Our Ref: QUK-JBAU-XX-XX-LT-HM-0001.docx

13 November 2025

12th November EA meeting - The Foundry - ENVPAC/1/HNL/00647 – Discharge of Planning Condition 25

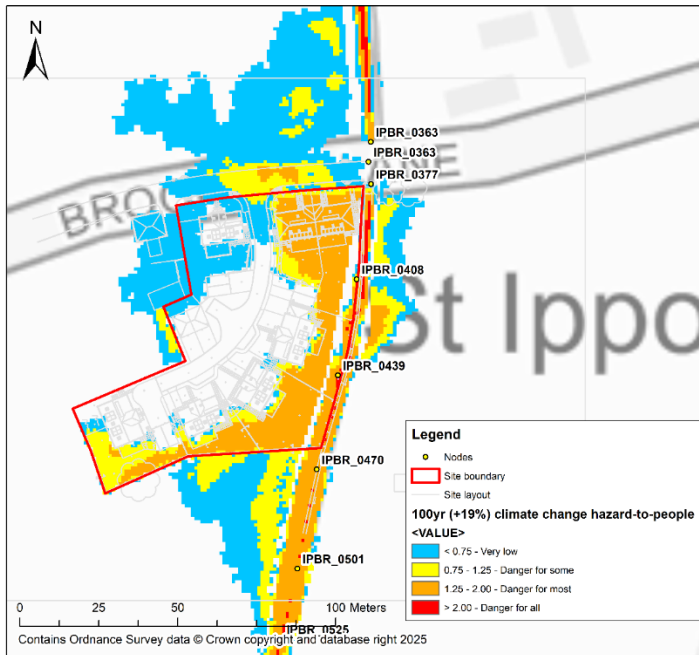
In addition to the above matters, you requested information concerning safe access and egress procedures on site. To alleviate your concerns, we have enclosed a copy of the Flood Response Plan (which has been

issued and validated by the Local Flood Emergency Planning team earlier this year) and produced an updated hazard-to-people map (below) to confirm the latest changes to the site topography have not lead to significant changes in the hazard-to-people categories used to produce the Flood Response Plan.
